NOTICE OF VIOLATION

On July 25, 2024, Energy Safety conducted an inspection of SCE's WMP initiatives in the vicinity of the city of Menifee, California. The inspection report is enclosed herewith. Energy Safety found the following violation(s):

INSPECTION REPORT

Electrical Corporation:	Southern California Edison Company				
Report Number:	CADSCE_SIS_20240725_1111				
Inspector:	Samuel Isaiah				
WMP Year Inspected:	2024				
Quarterly Data Report (QDR) Referenced:	Quarter 1 (Q1)				
Inspection Selection:	Energy Safety viewed the contents of the Q1 QDR and performed an analysis that resulted in the selection of				
	the WMP initiatives and locations referenced in this report.				
Relevant WMP Initiative(s):	8.1.2.1.1 Covered Conductor				
Date of inspection:	July 25, 2024				
City and/or County of Inspection:	Menifee, Riverside County				
Inspection Purpose:	Assess the accuracy of Southern California Edison Company's QDR data, completeness of its work, compliance				
	with WMP requirements, and compliance with its protocols.

Item1IA1Img1: No covered conductor present

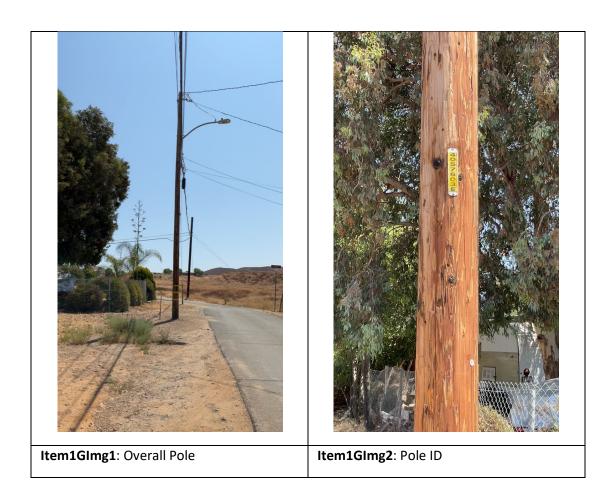
On Pole ID 4057603E, Grid Hardening ID TD2090512-4057603E, at 23998-23806 Johnson Ln, Manifee, CA, 92587, USA, 33.70991819829317, -117.24091850632244, the inspector observed that no covered conductor was present. The inspector's observation is documented in Violation 1 photographs, which are attachments to this report. Photo numbers Item1Glmg1, Item1Glmg2, Item1IA1Img1 depict that no covered conductor was installed at the location.

- 1. Southern California Edison Company's 2023 WMP Covered Conductor (8.1.2.1.1) work was identified as complete at this location.
- 2. Covered conductor was not installed.
